ARCHITECT'S SUPPLEMENTAL INSTRUCTIONS

PROJECT:	The Reserves at Magnolia New Apartment Complex Denton, TX	Report No.	One (1)
OWNER:	Overland Property Group Dan Maximuk 234 N. Santa Fe Ave, Suite A Salina, KS 67401	Date	Oct. 22, 2024
CONTRACTOR:	Snyder Construction Group 4820 N. Town Centre Dr. Ozark, MO 65721	Architect's Proj No.	21-3205
		Contract For:	General Construction Mechanical, Electrical

Please Note: Drawings and Specification Edits associated with this ASI are dated as **7-17-2024**. This date above is the date this ASI was issued.

A4.6

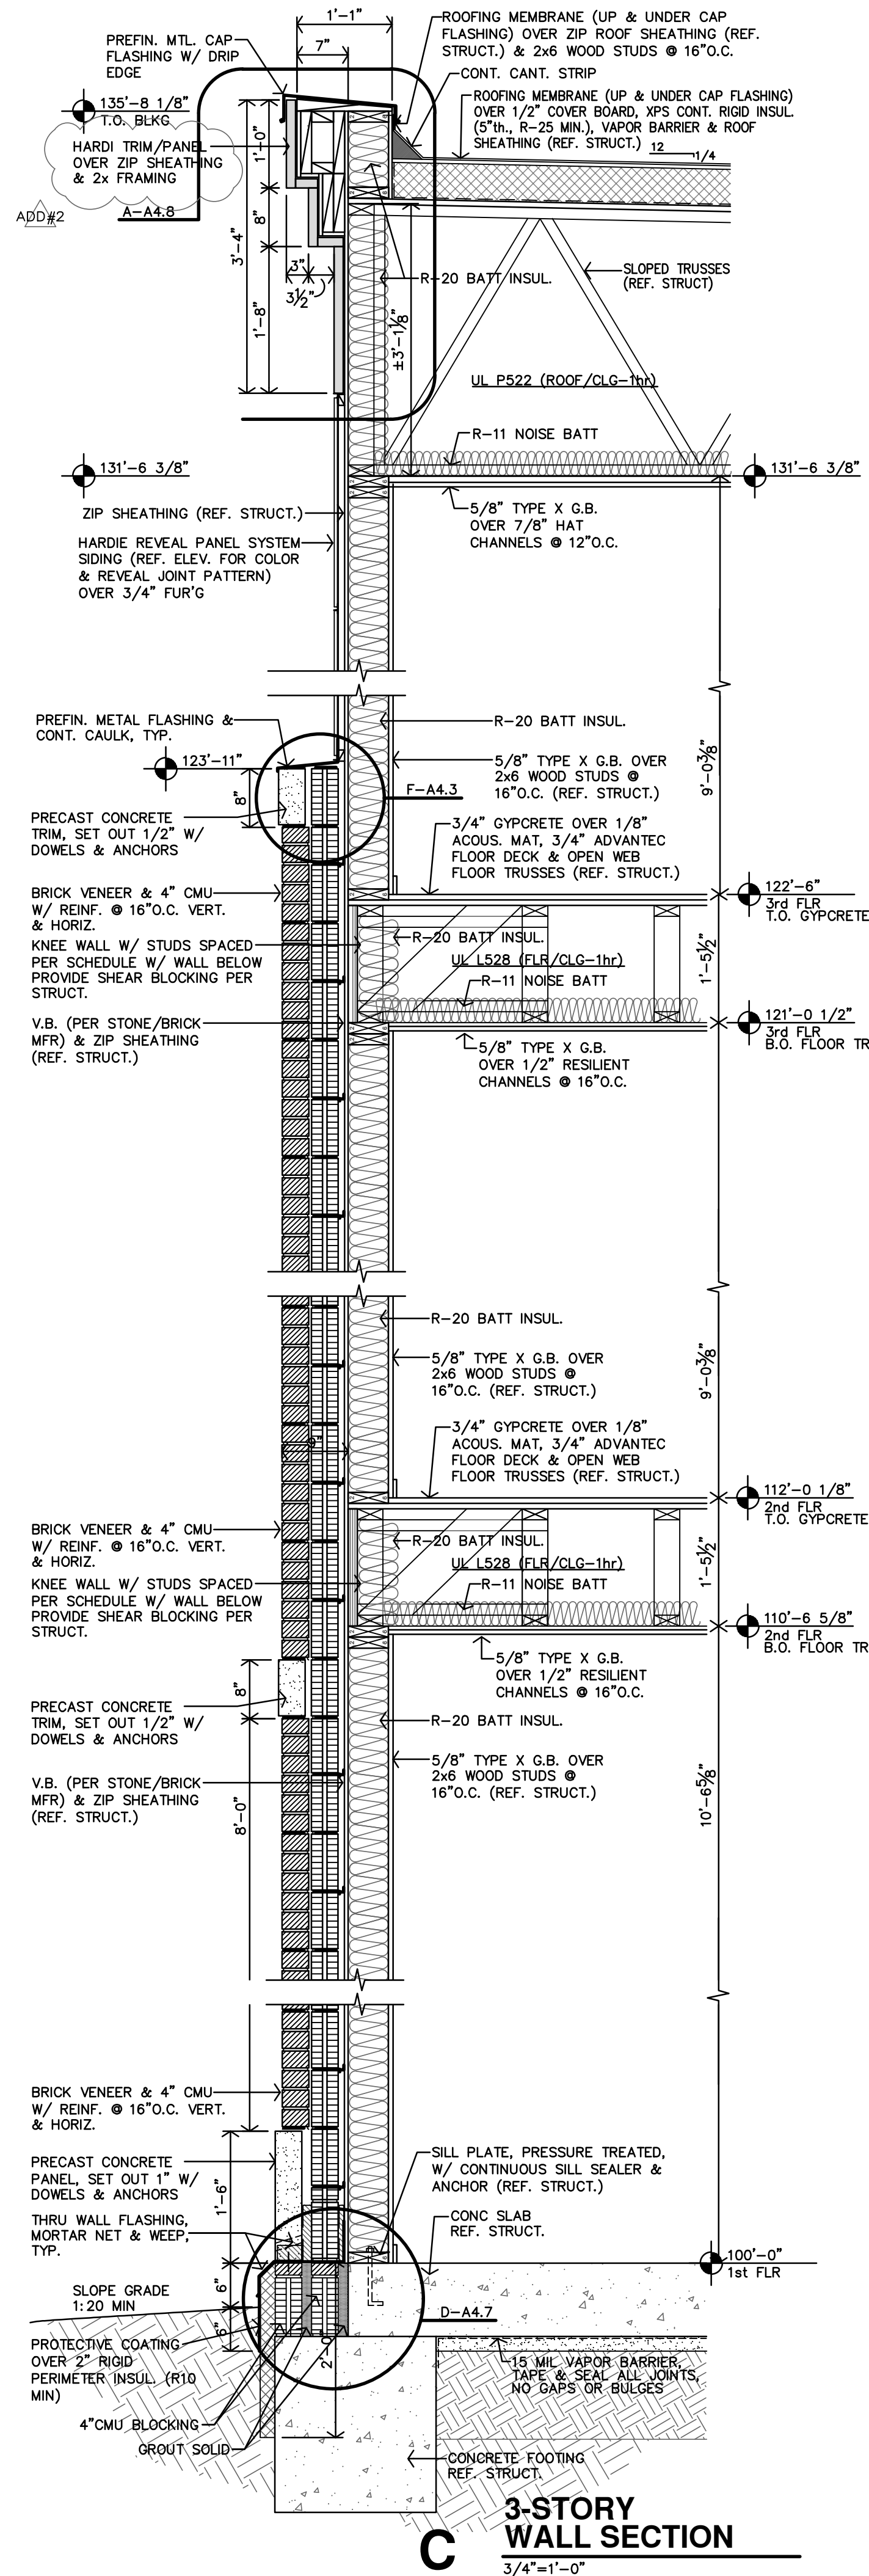
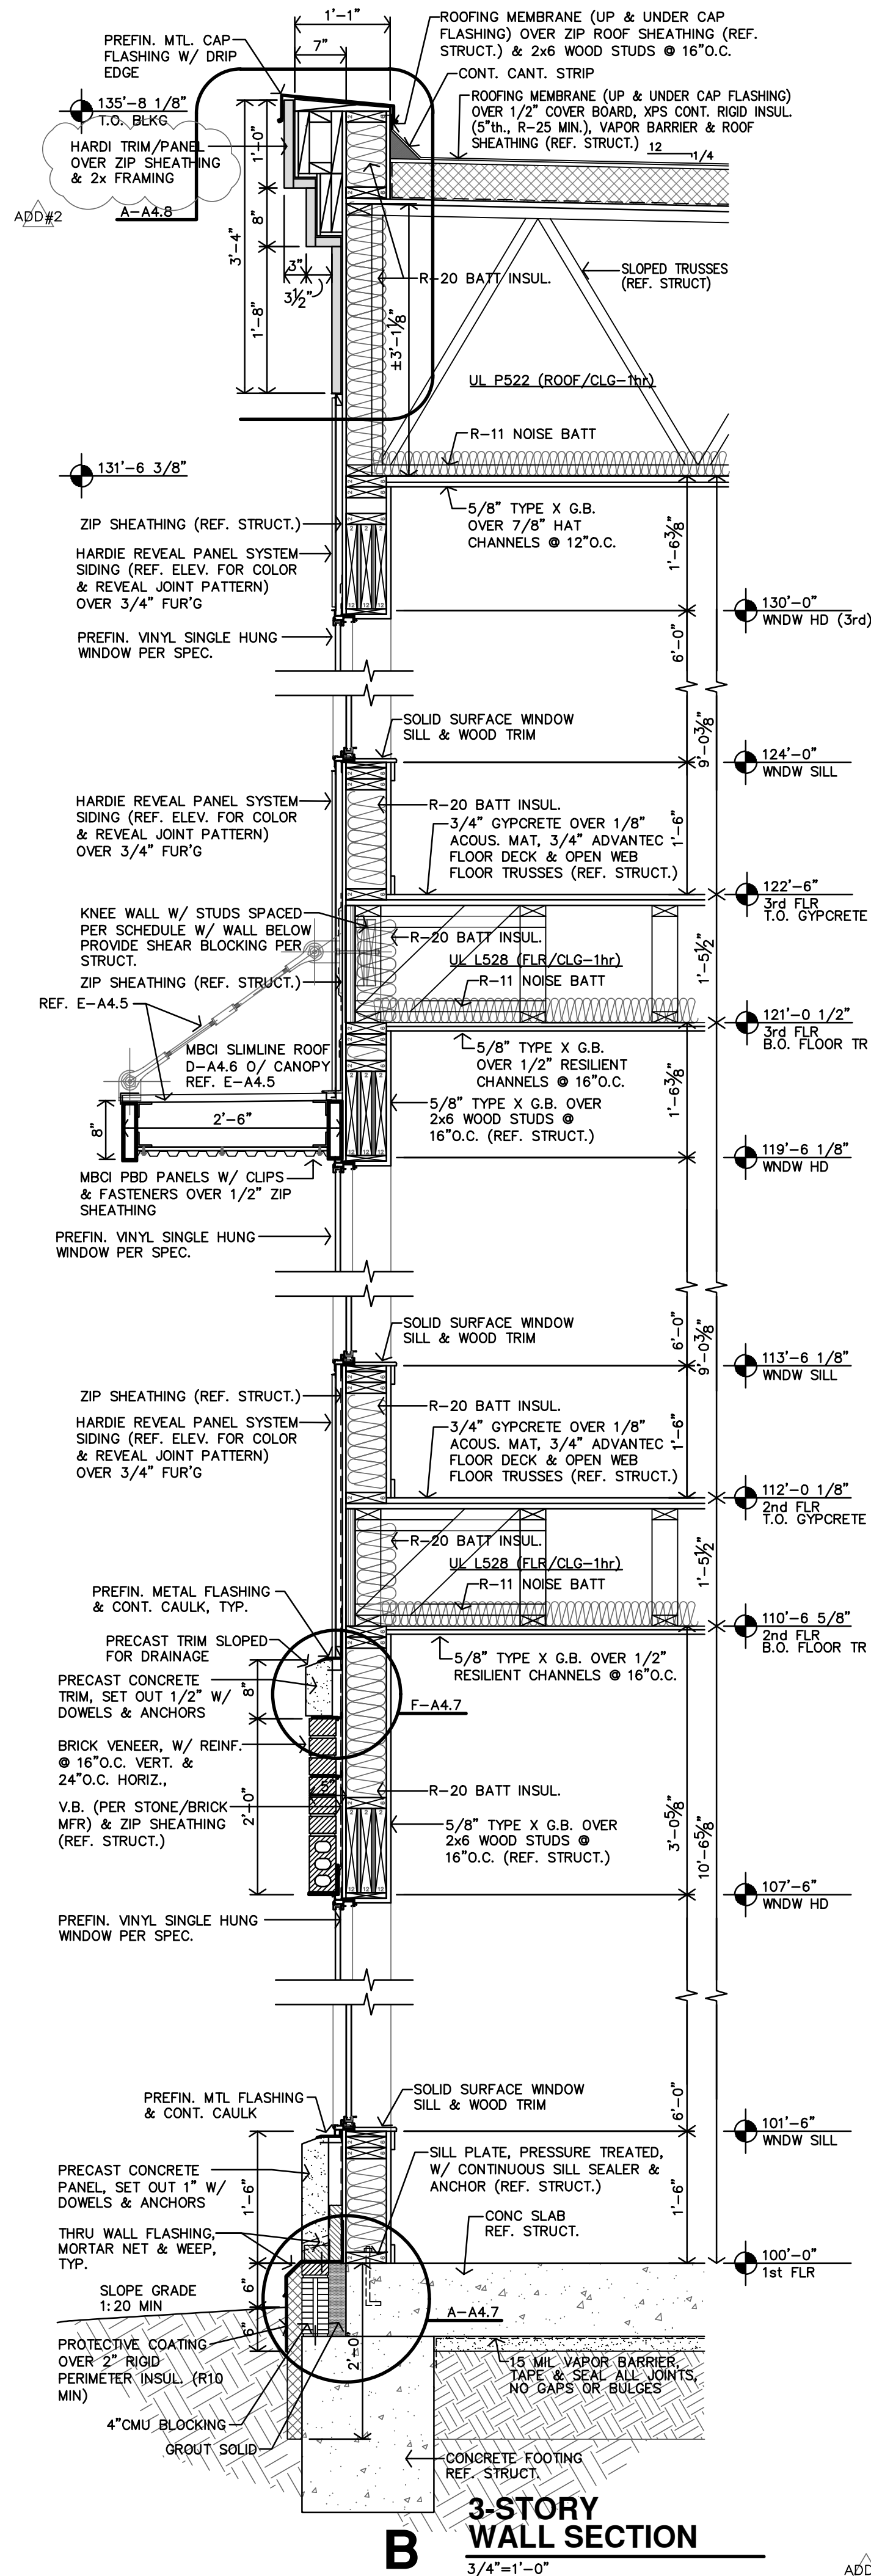
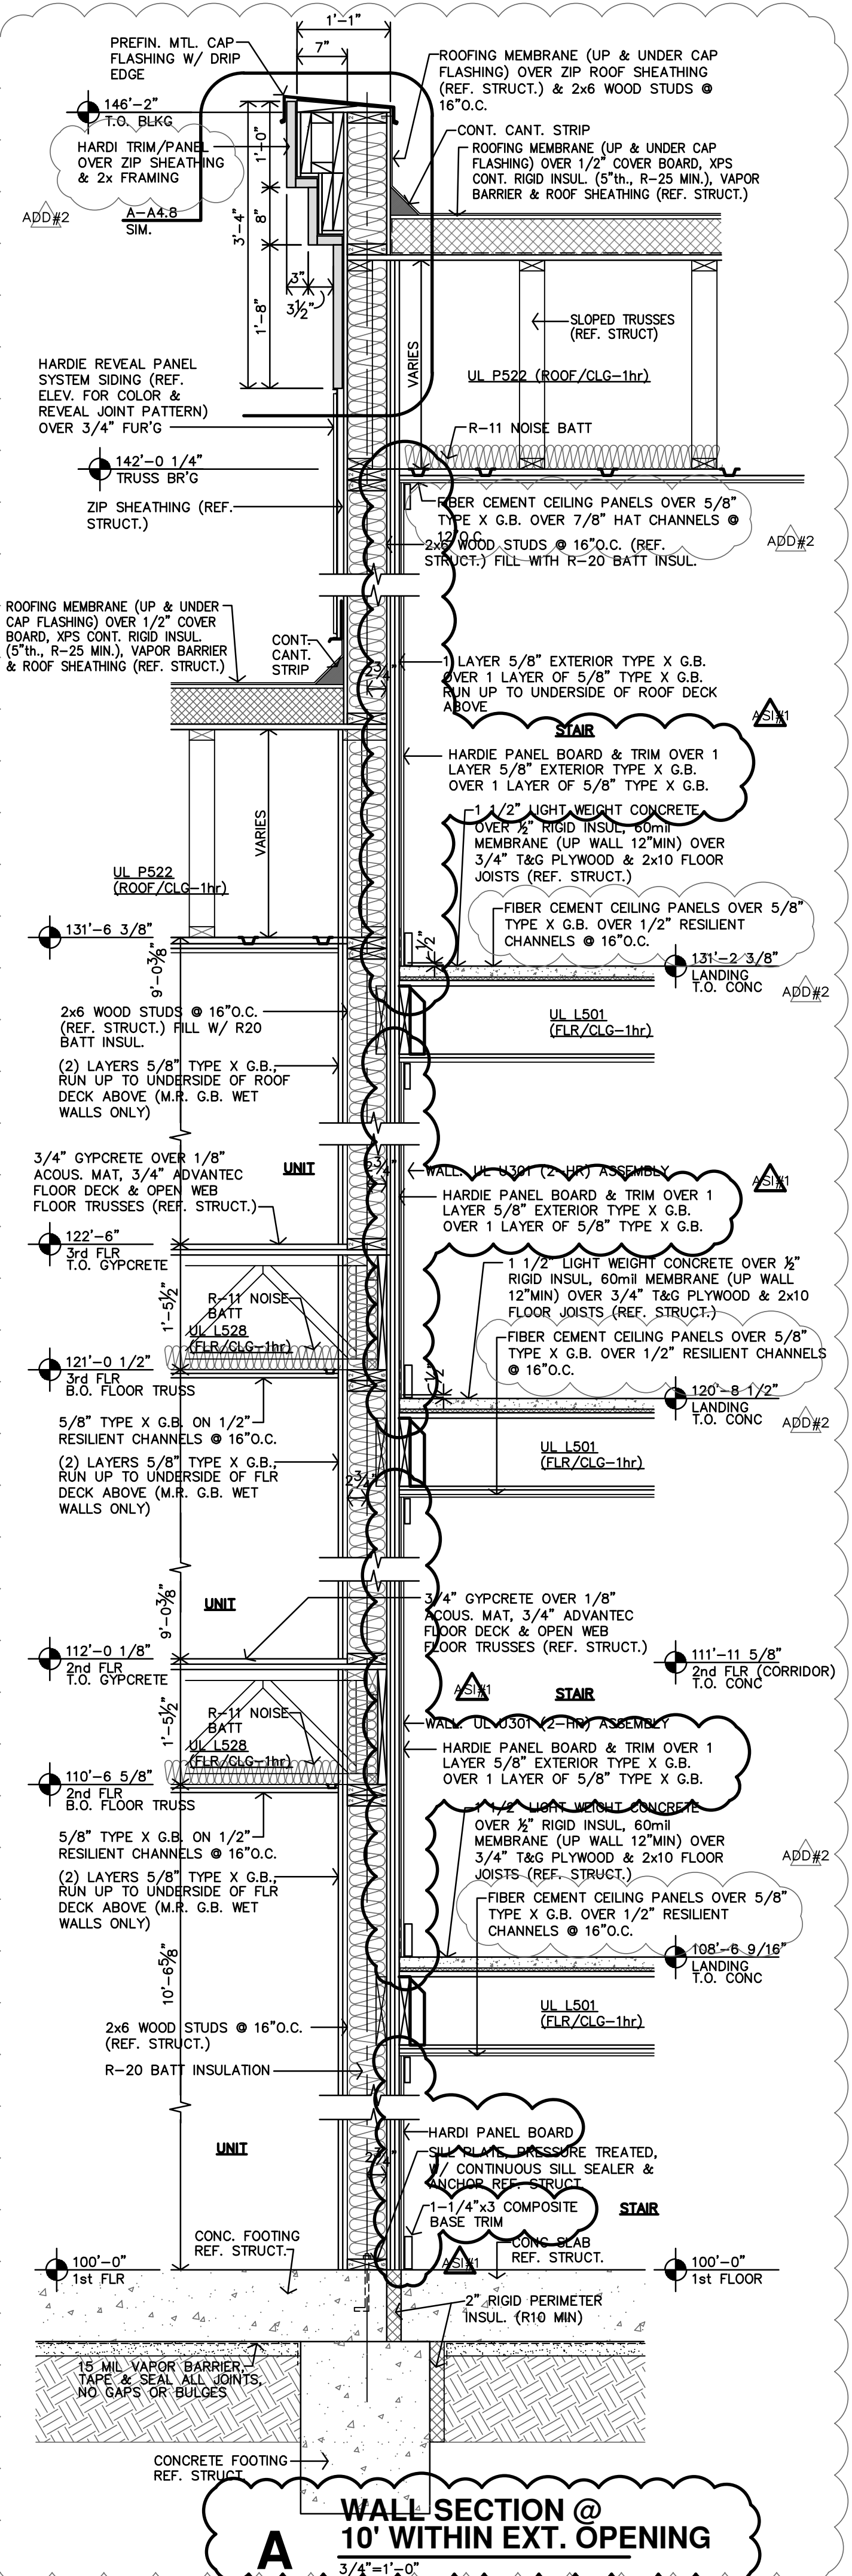
- 15) Utilize 5/8" type 'x' exterior-grade gypsum board finish at exterior breezeways in lieu of fiber cement siding and soffit. (VE Item #19) Exception: within 10 feet of each exterior opening. At these areas, fiber cement panel and trim shall be used. Reference revised details on Sheets A2.0, A3.3, A4.1, A4.6, A4.7, A4.8, A6.1, A6.2, A6.3, A7.1, A7.2, A7.3, and A7.4

A6.1

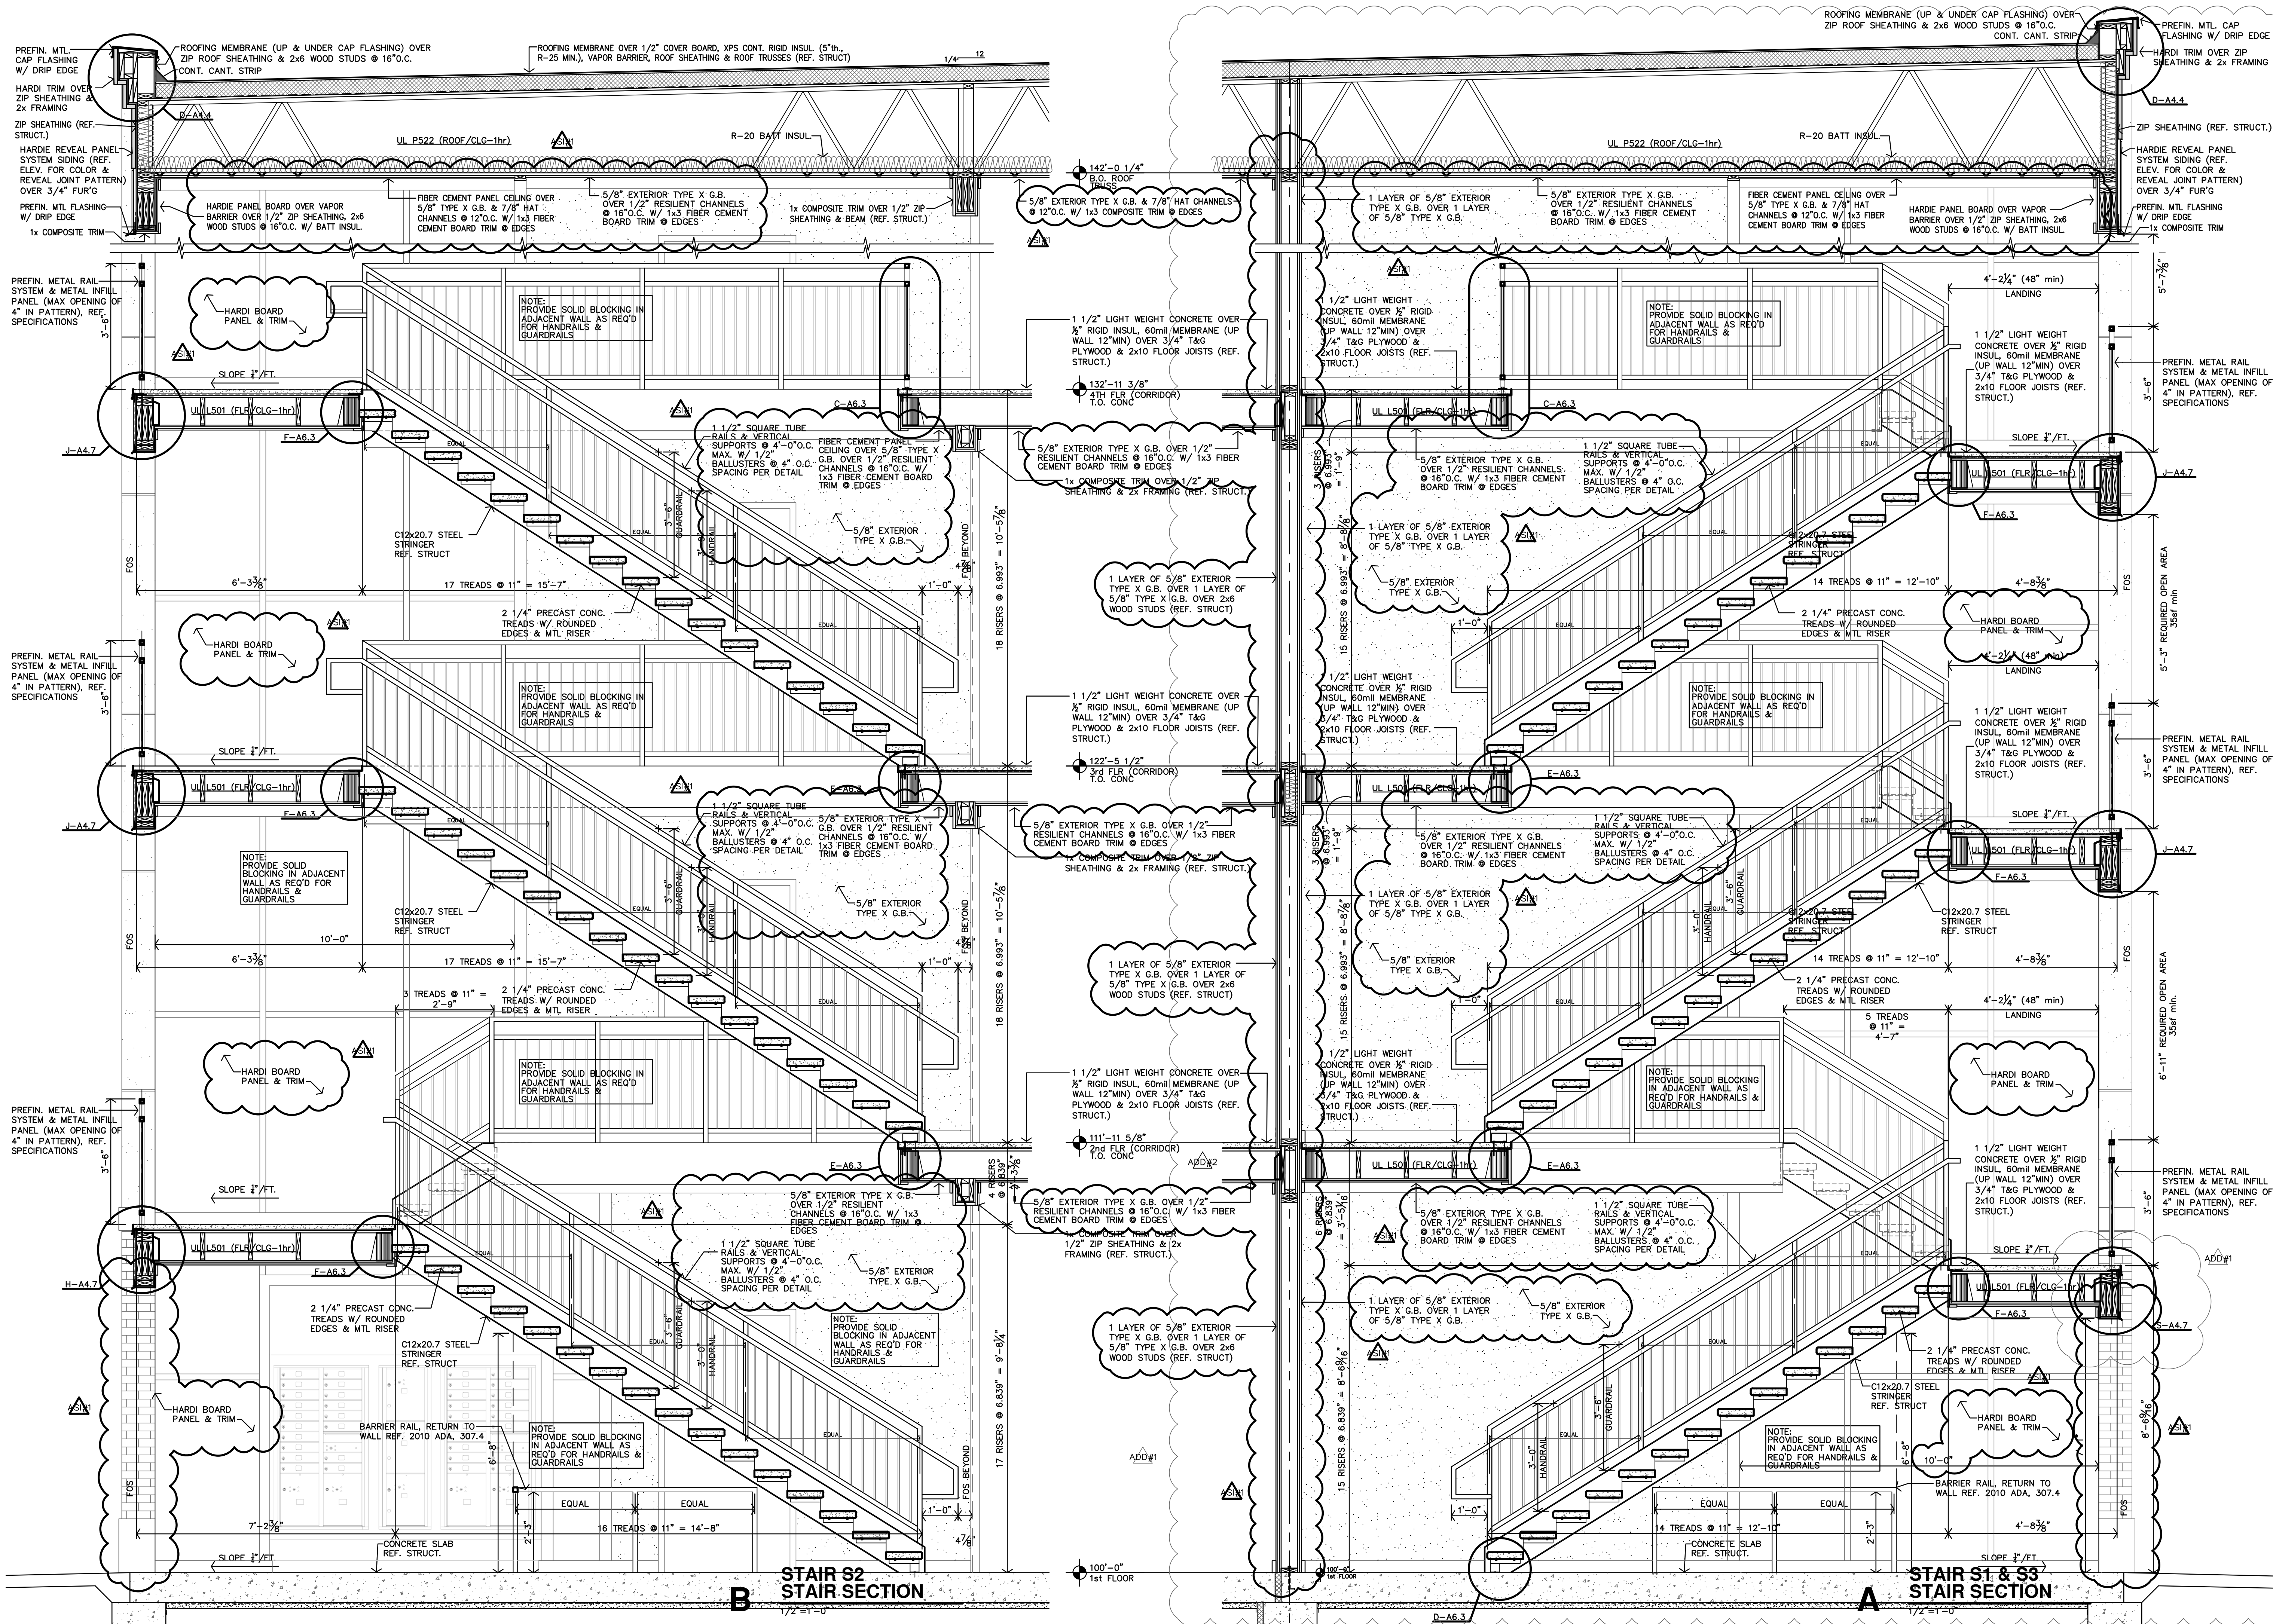
- 17) Omit Security Gate and Doors #114, #116, #121 and #122. (VE item #22). Reference revised plans and details on Sheets A2.1, A3.1, A3.2, A6.1, A6.2 and A10.2.
